NATIONAL TRANSPORTATION SAFETY BOARD

Group Chairman's Factual Report

WPR11MA454

**NORTH AMERICAN—INSTALLATION OF ELEVATOR INERTIA WEIGHT—
P-51B, P-51C, P-51D, F-6C, AND F-6D**

Figure 2 - View Showing Front Casting Installed - Horizontal Stabilizer

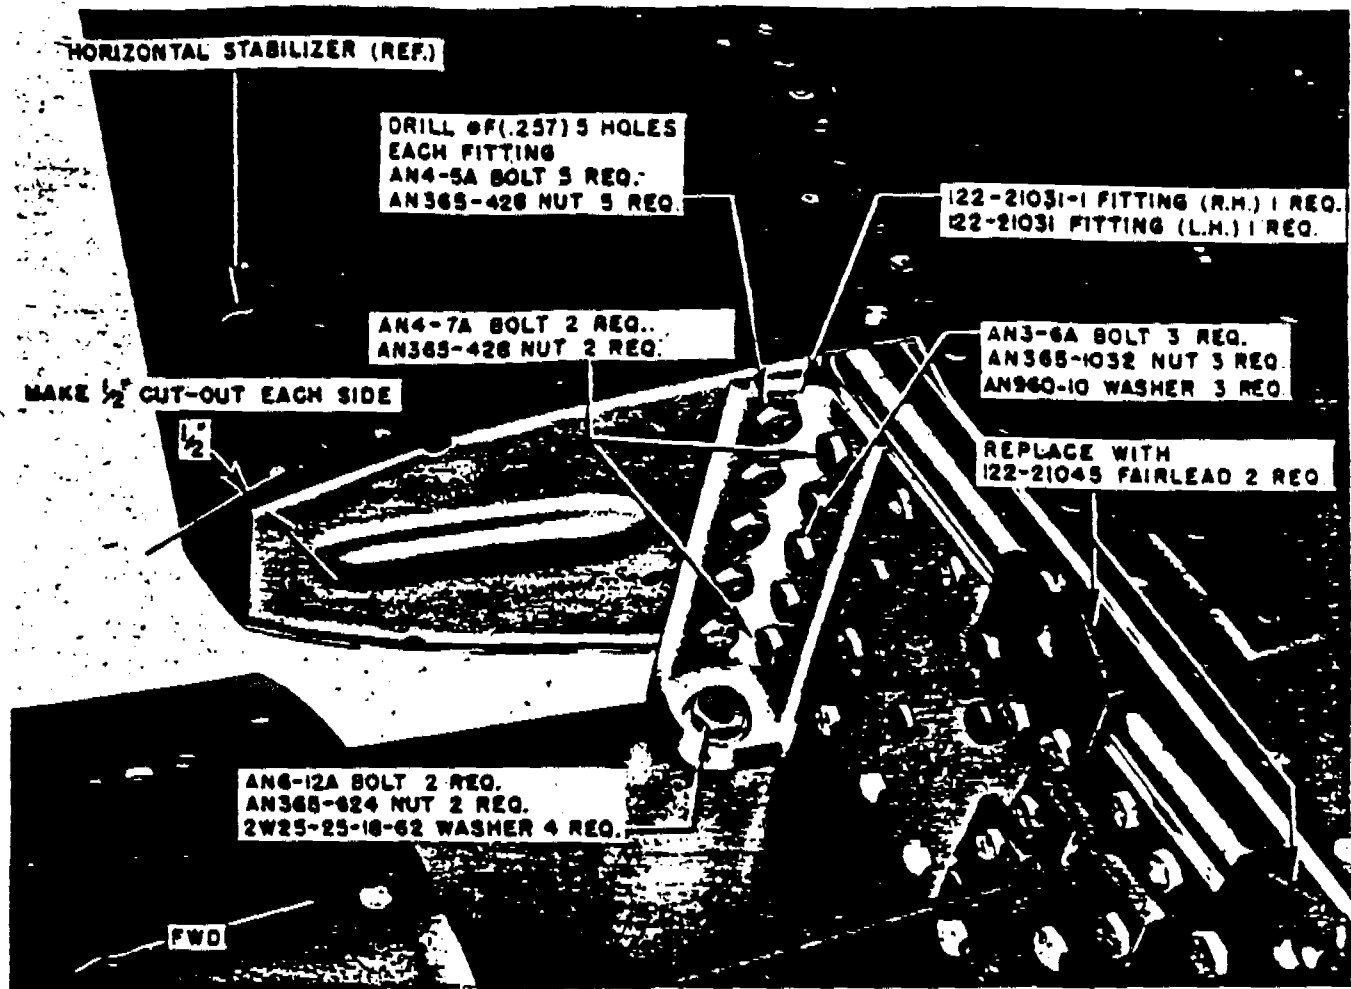
(3) Remove the five bolts and nuts securing each of the two front castings to the horizontal stabilizer. Remove the five rivets securing each casting. (See Figure 2.)

(4) Make a 1/2-inch cut-out in both leading edge center corners as shown in Figure 2. This will provide an opening through which a wrench may be inserted to install the new castings. (See Figures 2 and 3.)

(5) Temporarily bolt the fitting, part No. 73-21031, and the new fitting, part No. 122-21031, back with a new shim, part No. 122-21040, between the fittings. In this manner the holes in the old fitting will act as pilots when drilling holes in the new fitting. Use a No. 12 (.189-inch diameter) drill for holes in leg of fitting attaching to front beam of stabilizer. Follow the same procedure for the fitting, part No. 122-21031-1. (See figures 2 and 3.)

(6) Secure the left-hand fitting, part No. 122-21031 (right-hand fitting, part No. 122-21031-1), and the shim, part No. 122-21040, to the front beam of the horizontal stabilizer at the top and bottom holes with two each bolts, part No. AN4-7A, and nuts, part No. AN365-428. Install three each bolts, part No. AN3-6A, washers, part No. AN960-10, and nuts, part No. AN365-1032, in the remaining holes through fitting and beam. Nuts shall be on aft side of beam. Enlarge the five holes in the stabilizer rib through the holes in the fitting with a No. F (.257-inch diameter) drill. Install five each bolts, part No. AN4-5A, and nuts, part No. AN365-428. Nuts shall be on outboard side of rib. (See figures 2 and 3.)

Figure 5 - Looking Forward - Fitting, Vertical Stabilizer

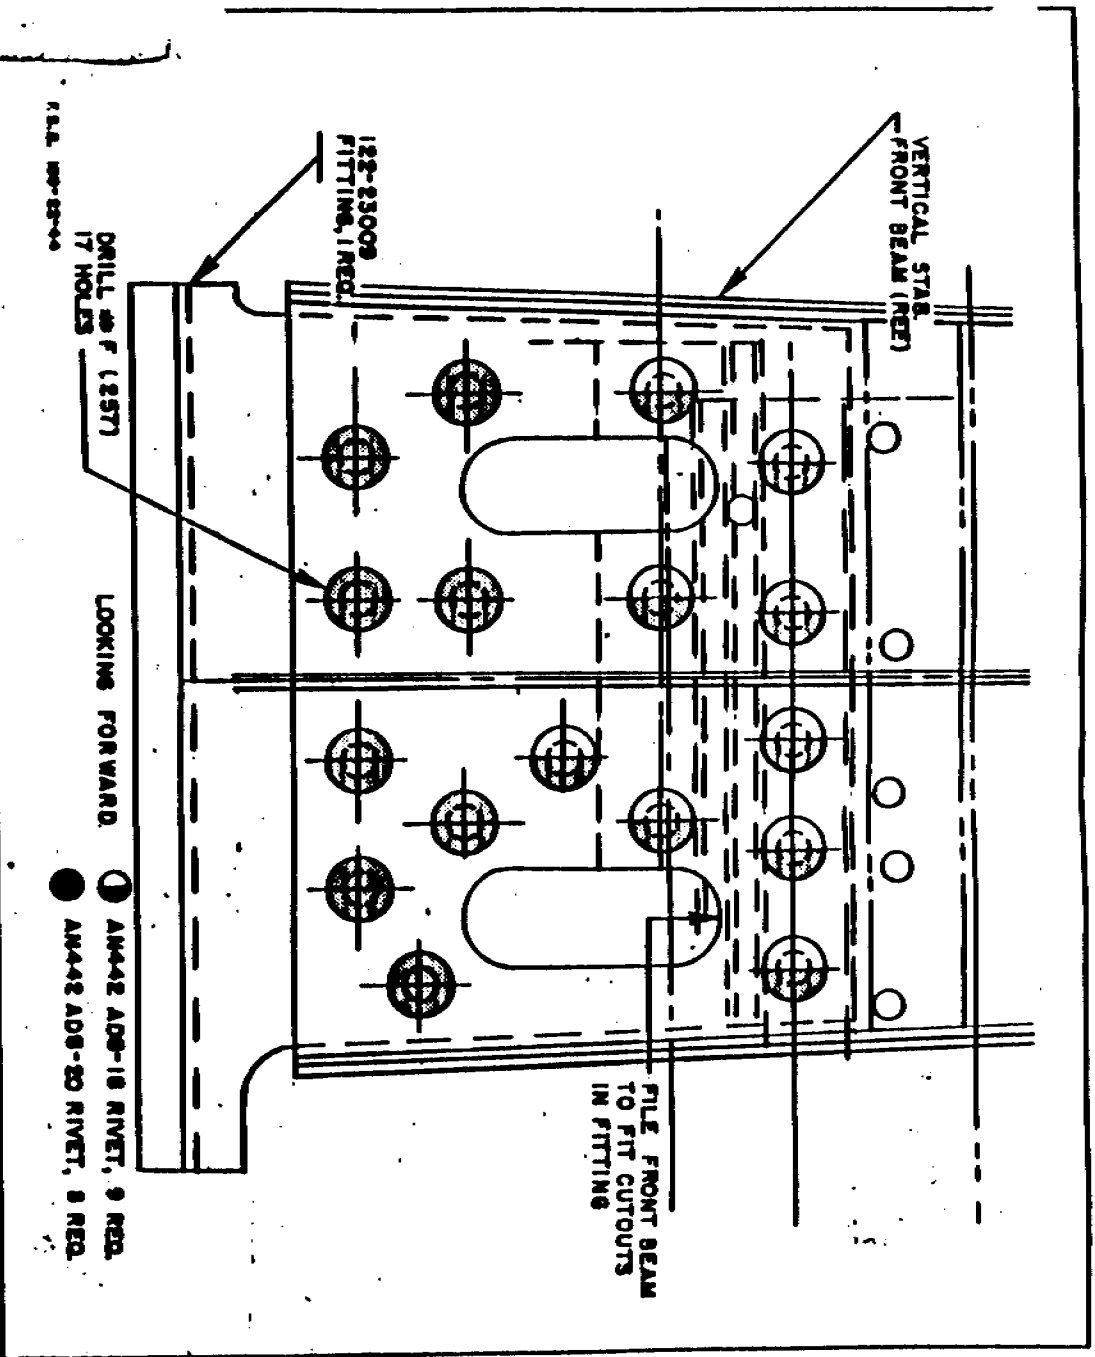
(3) Secure the new fitting, part No. 122-23009, in place of the one removed in the following manner: (See figure 5.)

(f) Drive eight rivets, part No. AN442AD6-20, and nine rivets, part No. AN442AD6-18, in the positions as shown in Figure 5.

Figure 6 - Installation of Shims - Fuselage Rear Section

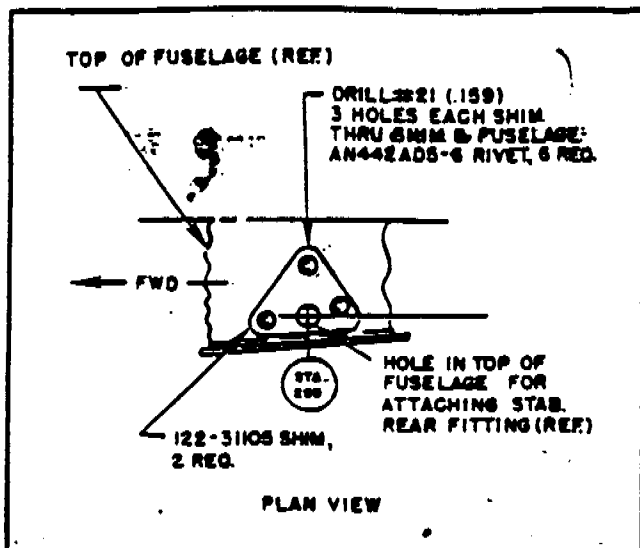
(1) Install a new shim, part No. 122-31105, over each horizontal stabilizer rear fitting attaching hole in the fuselage. Secure each shim with three rivets, part No. AN442AD5-6, as shown in figure 6. (See figures 4 and 6.)

Figure 7 - Installation of Bracket and Roller Assemblies

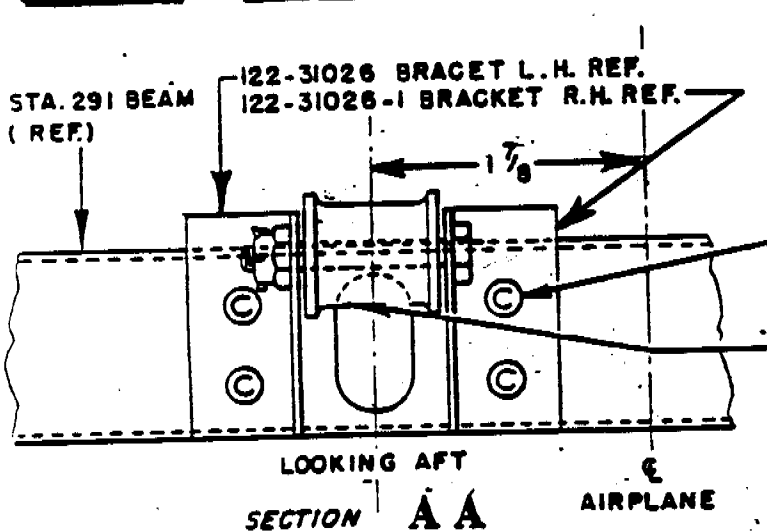
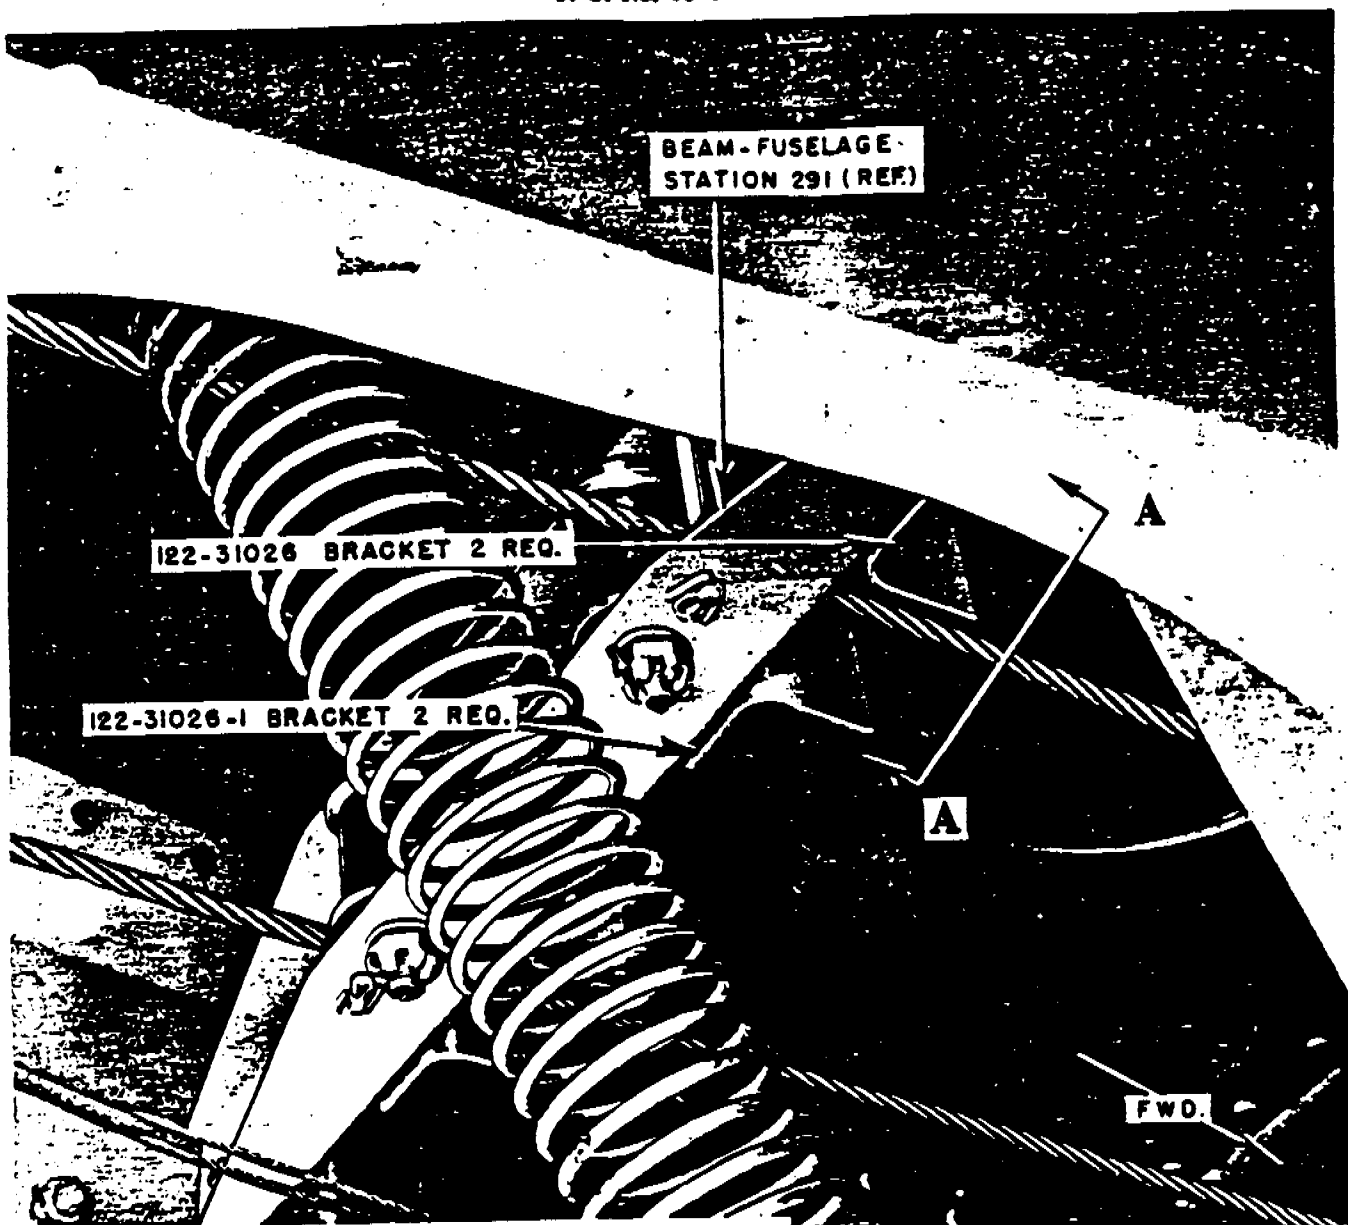
(2) Locate the two holes in the fuselage station 291 beam where the elevator control cables pass through. (See figure 7.)

(3) Install a new bracket and roller assembly over each hole on the forward side of the beam in the position shown. (See figure 7.)

DRILL FOUR #30(.128) HOLES
THRU BRACKET AND BEAM.
AN 442 AD4-5 RIVET 4 REQ.

- 6P2 PULLEY, 1 REQ. EACH SIDE
- AN3-14 BOLT, 1 REQ. EACH SIDE
- 109-33562 SPACER, 1 REQ. EACH SIDE
- AN310-3 NUT, 1 REQ. EACH SIDE
- AN380-2-2 COTTER, 1 REQ. EACH SIDE

Figure 8 - Installation of Roller Declutching Mechanism

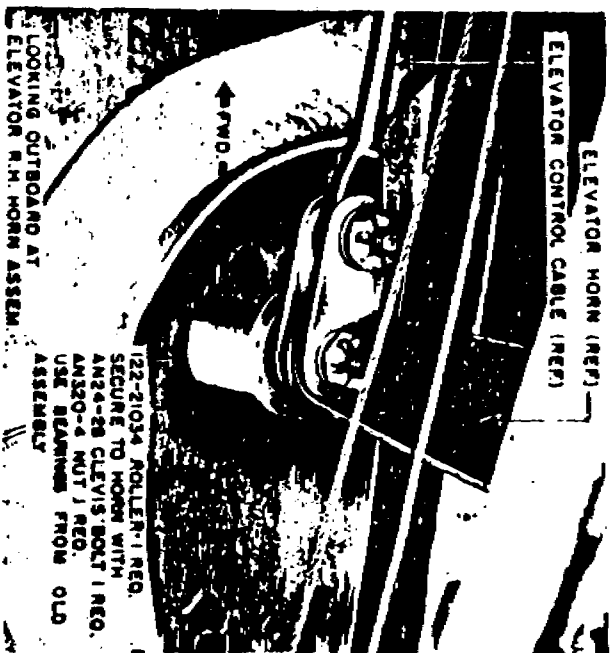
(4) Remove the two bearings from the lower end of the right-hand elevator horn and replace them as shown with a new roller assembly, part No. 122-21034. Secure with one clevis bolt, part No. AN24-28, and one nut, part No. AN320-4. (See figure 8.)

FIG. 1

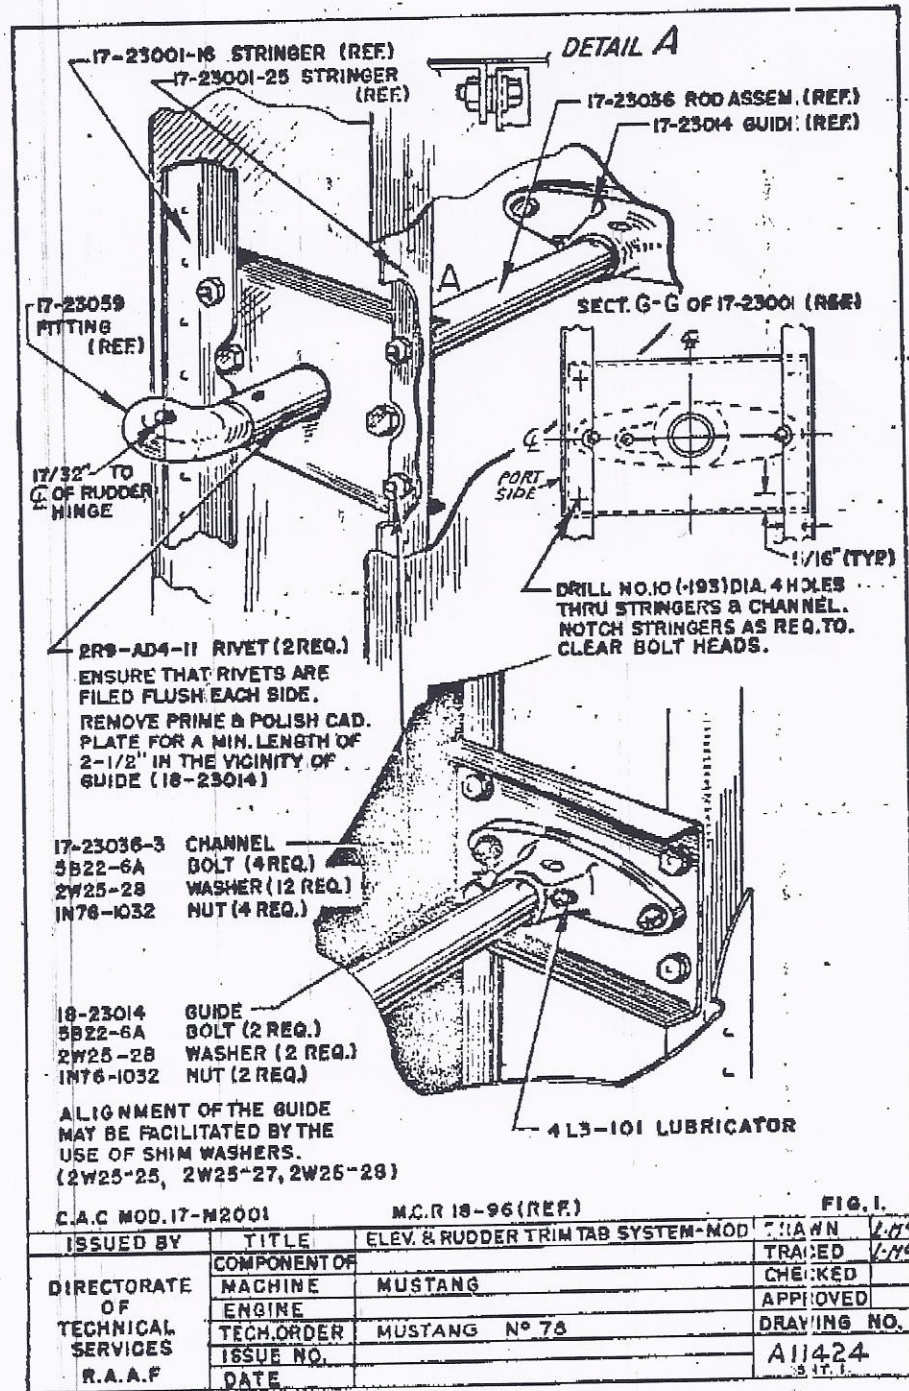
15. Locate channel, Part No. 17-23036-3 (Item No. 3) to dimensions as shown on the attached Drawing No. A11424 (Sheet 1) (Figure 1.). Rework stringers, Part No. 17-23001-16 and -25 as required to give clearance to the attachment bolt heads of guide bearing, Part No. 18-23014 (Item No. 2).

16. Drill No. 10 (.193) 4 holes, through stringers, Part No. 17-23001-16 and -25 and channel, Part No. 17-23036-3 (Item No. 3), at dimension as shown on the attached Drawing (Figure 1).

- Notes (1) Washers, Part No. 2W25-28 (Item No. 7) to be located as shown on the attached Drawing (Figure 1).
- (2) Alignment of the guide bearing, Part No. 18-23014 (Item No. 2) may be facilitated by the use of shim washers, Part No. 2W25-25 (Item No. 10), 2W25-27 (Item No. 11) and 2W25-28 (Item No. 12) as required.

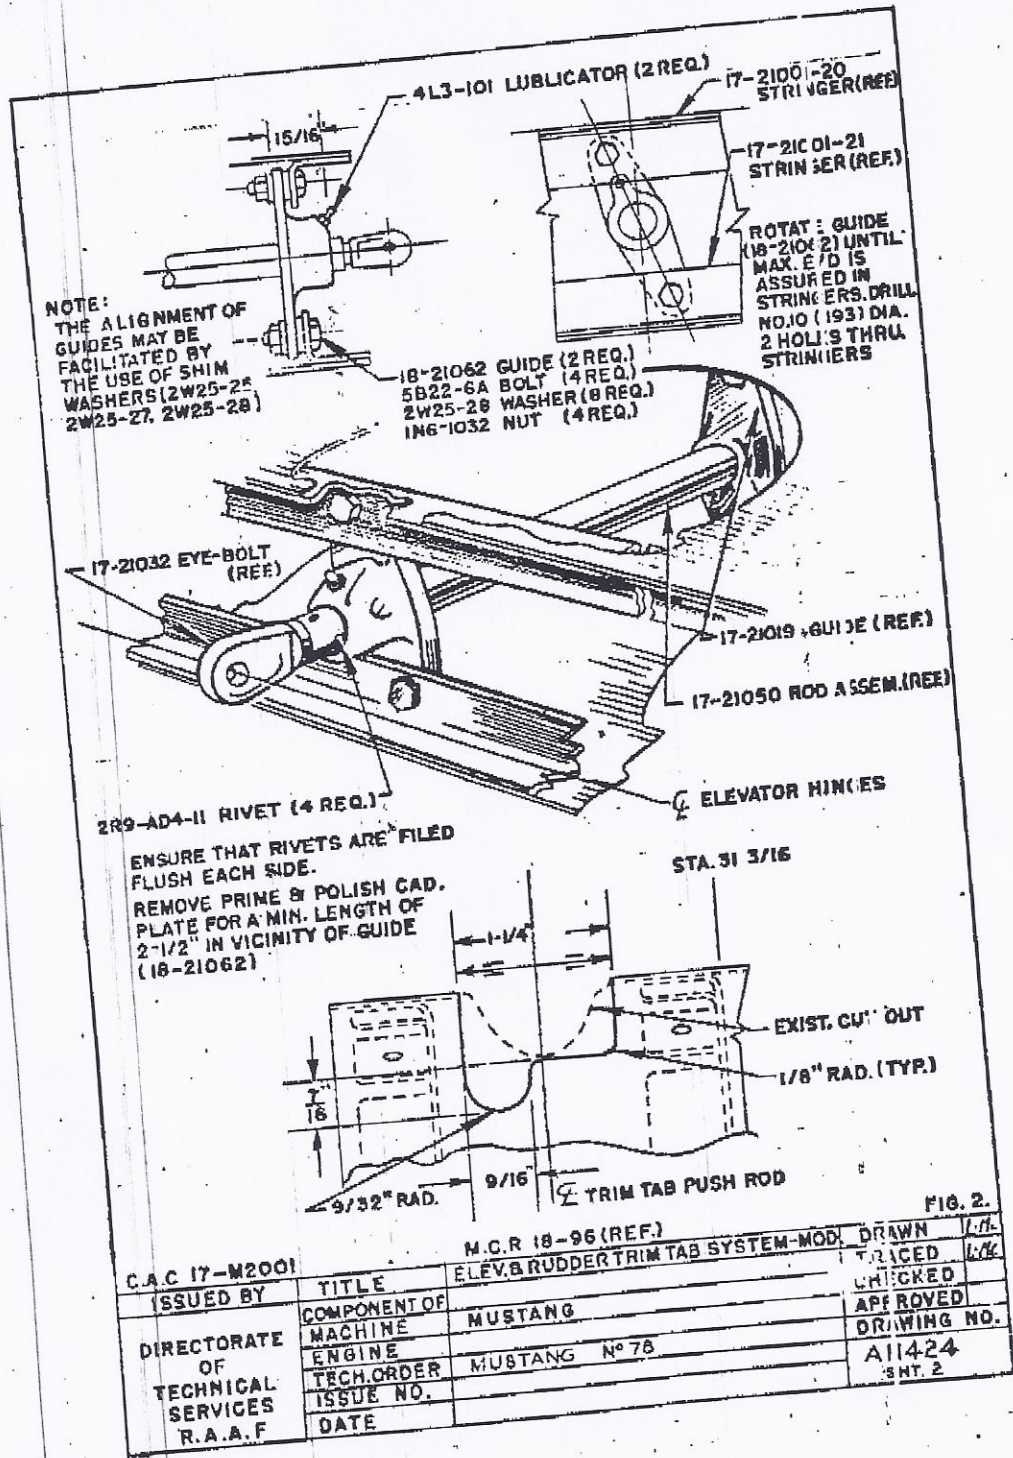
32. Locate guide bearing, Part No. 18-21062 (Item No. 1) as shown on the attached Drawing (Figure 2). Ensure that the guide bearing, Part No. 18-21062 (Item No. 1) is rotated until maximum edge distance is obtained in tailplane stringers, Part Nos. 17-21001-20 and -21.

33. Drill No. 10 (.193) diameter 2 holes through tailplane stringers, Part Nos. 17-21001-20 and -21 as shown on attached drawing (Figure 2).
